**RE: Restaurant Depot  
1901 Menaul Blvd NE  
Permanent C.O. – Accepted  
Engineer’s Certification Date: 11/14/23  
Engineer’s Stamp Date: 08/11/22  
Hydrology File: H15D039**

Based on the Certification received 12/08/2023 and site visit on 11/15/2023, this letter serves as a “green tag” from Hydrology Section for a Permanent Certificate of Occupancy to be issued by the Building and Safety Division.

## DRAINAGE CERTIFICATION

GRADING PLAN  
 SHEET TITLE  
 SHEET NUMBER

**C4.0**

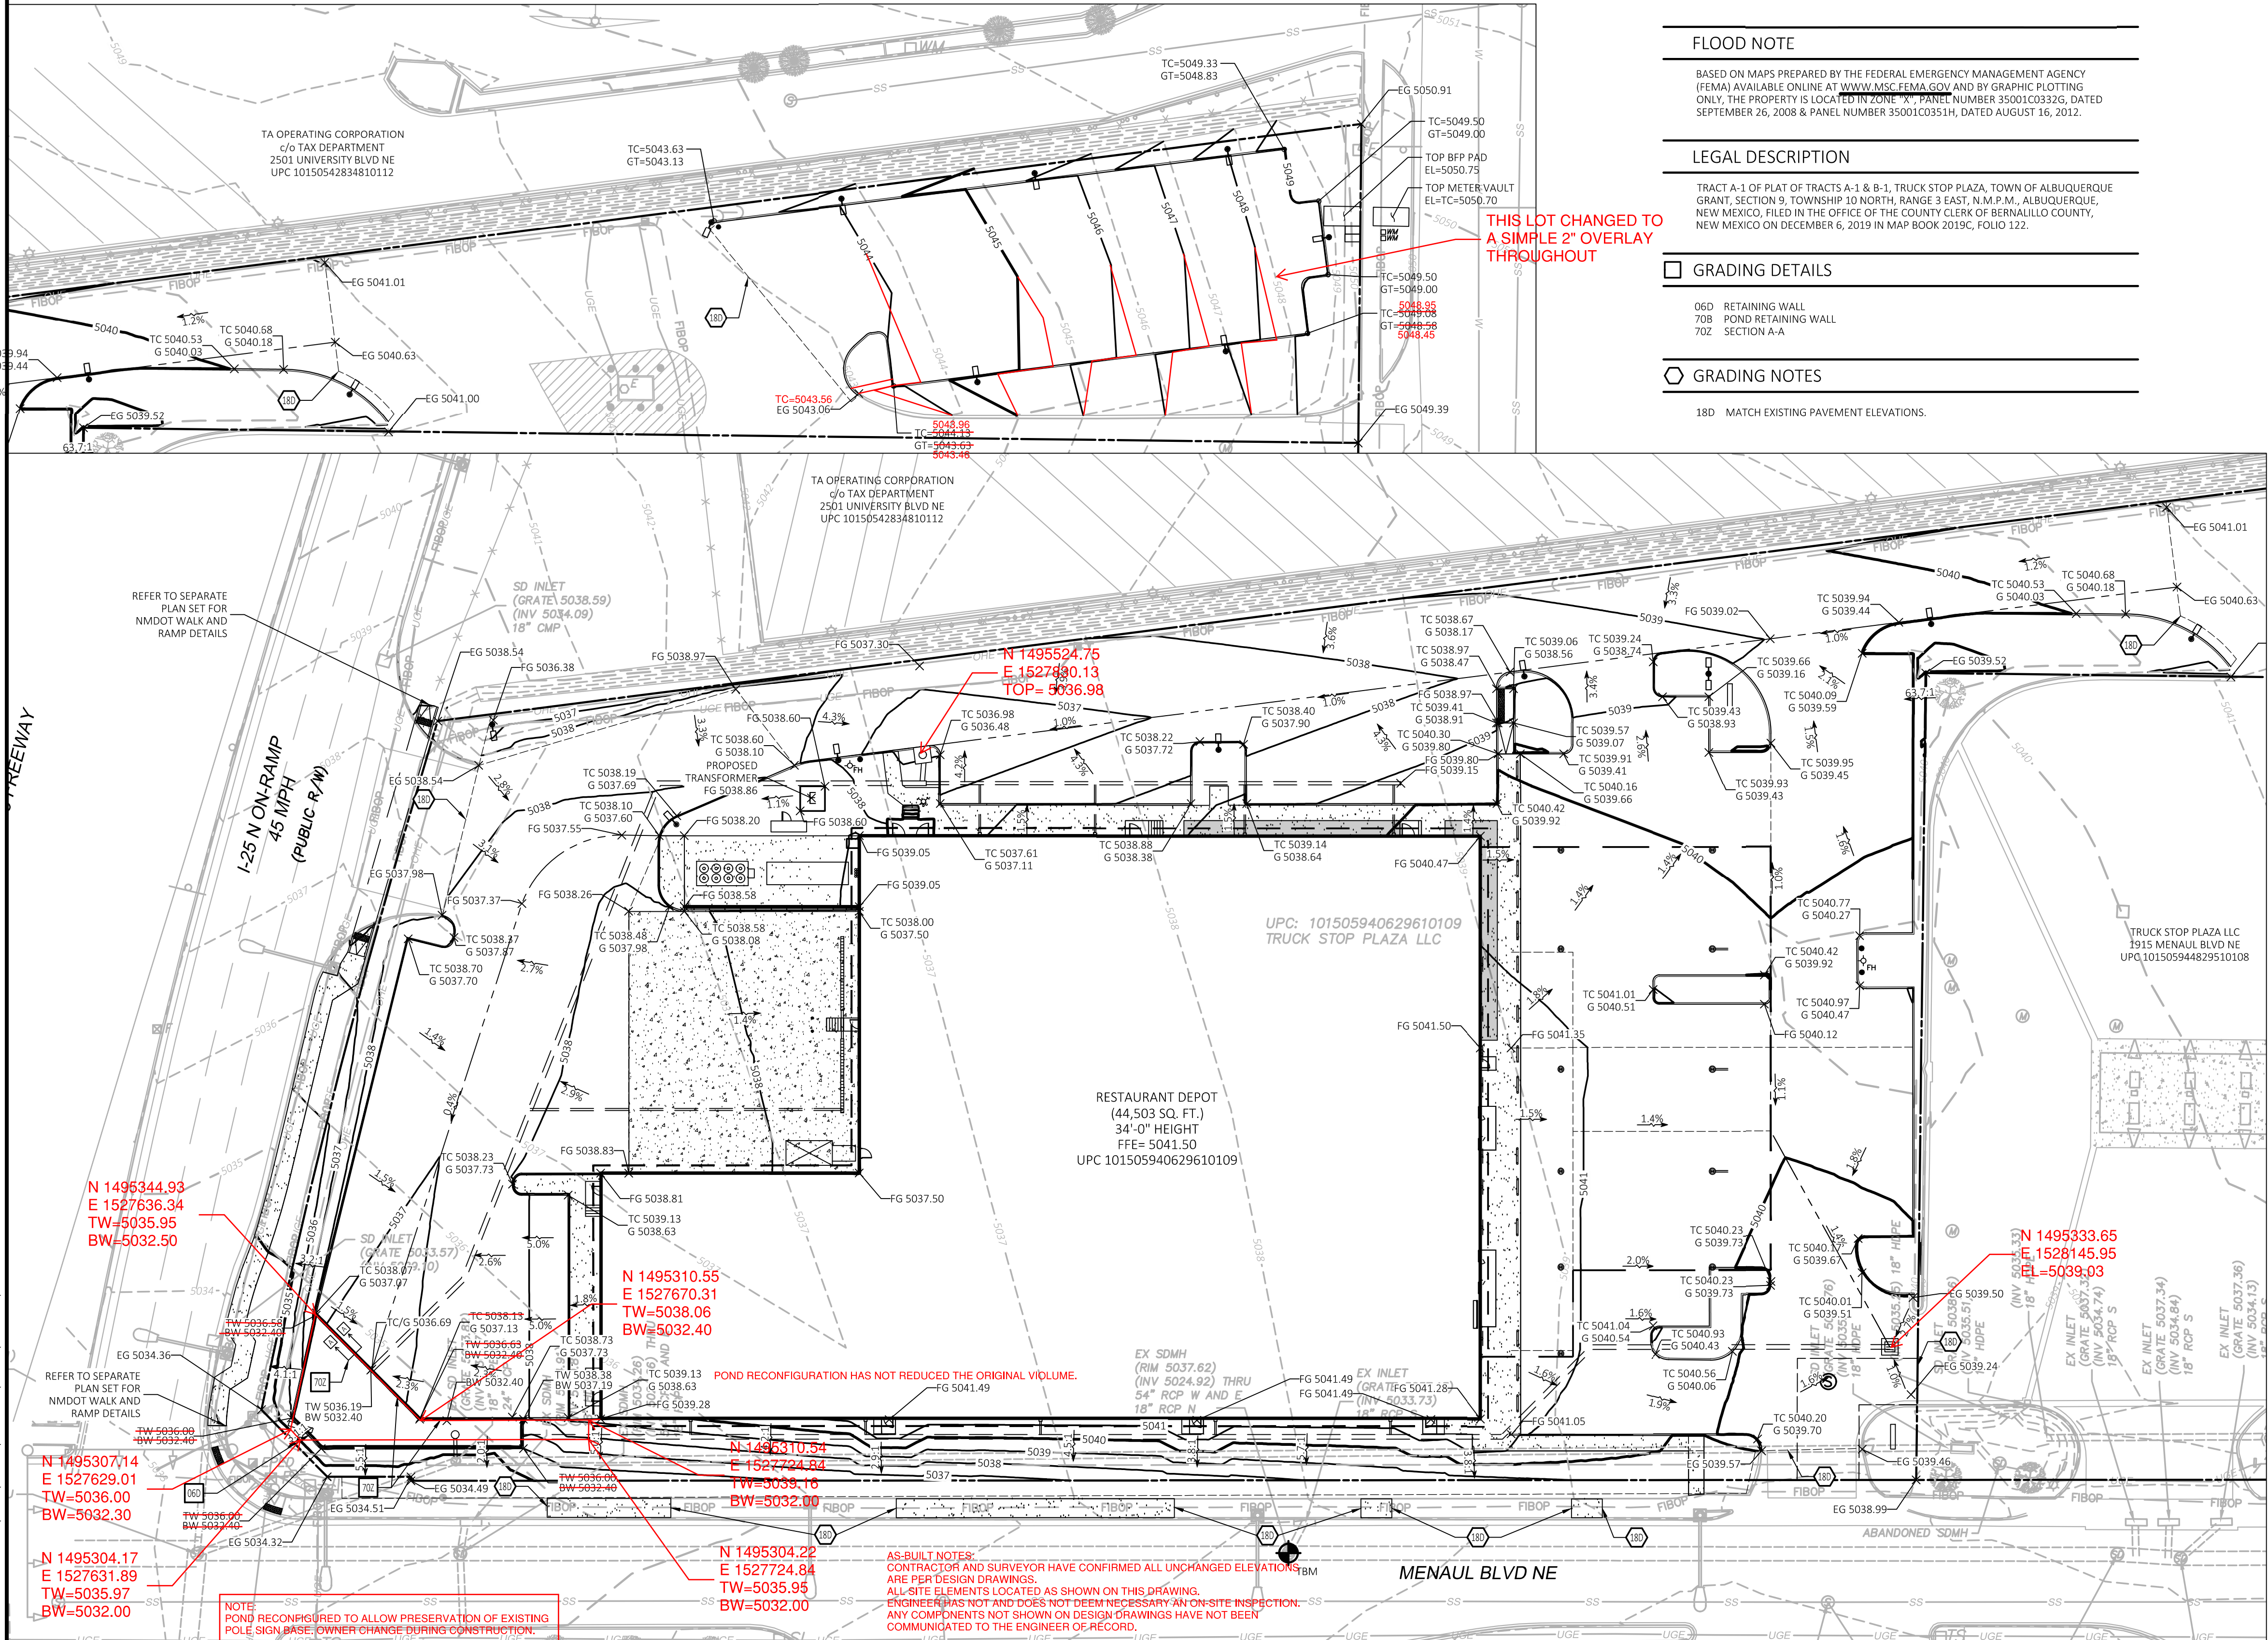
A small flume serving the remote lot was added to allow paving overlay with minimum disturbance to the existing substructure and the outlet pond was reconfigured but not reduced in capacity to allow preservation of the existing pole sign in the southwest corner of the development.
